October 22, 2001

**Subject: Re: Amendment 1 to Source Material License SUA-1548
Flare Factor Estimate Change and Justification
License No: SUA-1548 Docket No: 40-8964
Smith Ranch Facility**

SECTION 7
GROUNDWATER RESTORATION COSTS
Cost Summary

Figure 7-1. Predicted wellfield flare factor for RAMC commercial wellfields, as a function of wellfield scale

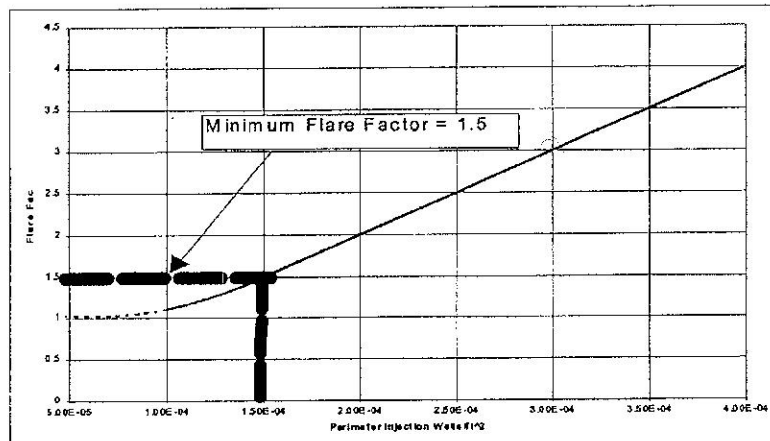
In response to Amendment 1 to Source Material License SUA-1548, dated September 27, 2001, Rio Algom Mining Corp. is submitting changes to the license application dated November 15, 1999, as amended. These changes include amended language in Sections 6.2.7 and 6.2.8 as well as changes in Appendix 7 for Chapter 6 of Volume I of the License Application. These changes reflect the methodology used by RAMC to estimate the flare factor of its wellfields for the development of the reclamation bond amount. As justification for the flare factor estimate methodology, RAMC has also attached the groundwater modeling report performed by a groundwater consultant. This report will be amended to the license application as Appendix K in Volume V.

Figure 7-1 is derived from Figure 3-16 in "Evaluation and Simulation of Wellfield Restoration at the RAMC Smith Ranch Facility" dated October 29, 1999 (provided as Appendix K of this application). This document was submitted to the Wyoming DEQ - Land Quality Division with a letter dated December 13, 1999 for review. In that document, RAMC proposes a methodology developed through hydraulic and geochemical modeling that uses the geometry of the wellfield to estimate a Flare Factor. In this case, the number of perimeter injection wells are counted, the surface area of the wellfield pattern is measured using a wellfield map, a ratio is developed of the # of perimeter injection wells to the surface area of the wellfield patterns. That ratio is located on the horizontal axis of figure 7-1 (above). From that intercept, a vertical line is projected to intersect the curve. At that intersection, a horizontal line is projected to intercept the vertical axis. The estimated flare factor is derived from that intercept.

| Wellfield | Number of Perimeter Injection Wells | Measured Pattern Area (ft ²) | Perimeter Inj Wells per Unit Area | Number of Patterns | Average Open Interval (ft) | Effective Porosity | Flare Factor from Fig 7-1 | Pattern Affected Pore Volume (gal/pattern) | Wellfield Affected Pore Volume (gallons) |
|-----------|-------------------------------------|--|-----------------------------------|--------------------|----------------------------|--------------------|---------------------------|--|--|
| 1 | 170 | 1115229 | 1.52E-004 | 116 | 18 | 0.27 | 1.7 | 594,146 | 68,920,890 |
| 3 | 147 | 1622462 | 9.06E-005 | 162 | 20 | 0.27 | 1.5 | 606,801 | 98,301,728 |
